SB 3-873-002

SUBJECT: INTERMITTENT SHUTDOWN OF TRANSMISSION ECU ON WX TRUCKS WITH NEW DASH

Figure 2

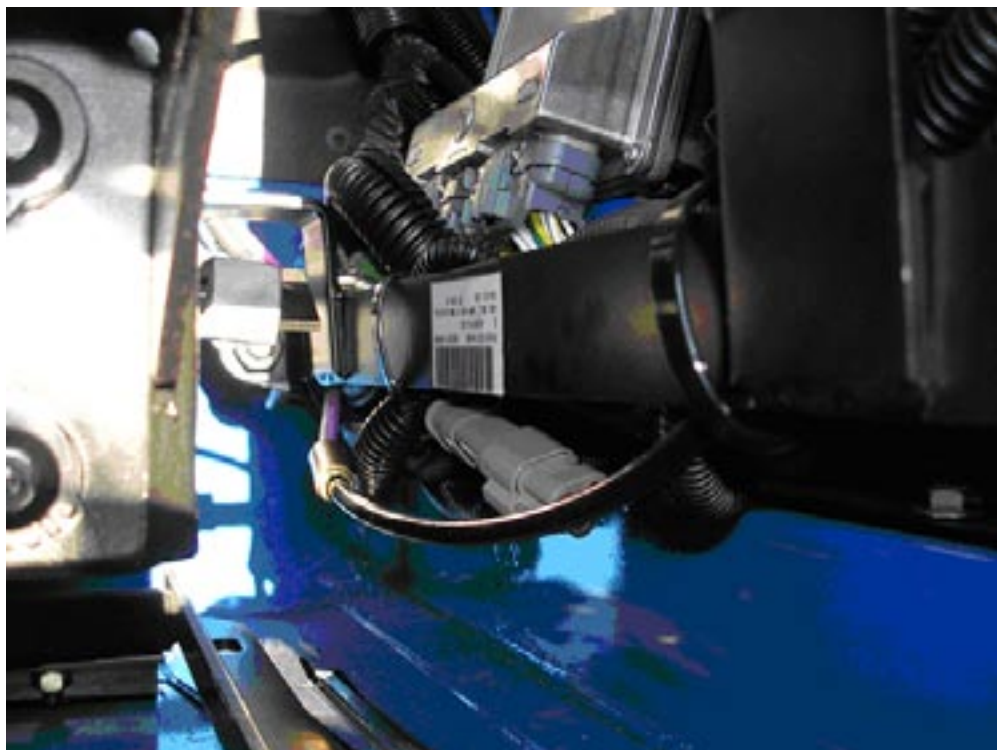
The root cause has been determined to be incorrect routing of the transmission ECU and main cab harness behind the LH seat. The wiring behind the seat at or near the transmission ECU contacts the seat as it travels, which causes the connectors to be unplugged and or damaging (chafing) the wiring harness. See **Figure 1** and **Figure 2**.

INCORRECT ROUTING, WIRING IN CONTACT WITH SEAT

1. Park the vehicle on a level surface. Turn off the engine, apply the parking brakes, and chock the rear tires to keep the vehicle from moving.
2. Locate the transmission ECU behind the LH seat.
3. Reroute the harnesses to the side and over the top of the transmission ECU and secure with cable ties and cushioned loom clamps. See **Figure 3** and **Figure 4** on page 5.
4. Repair any chafed wires and secure any loose connectors.
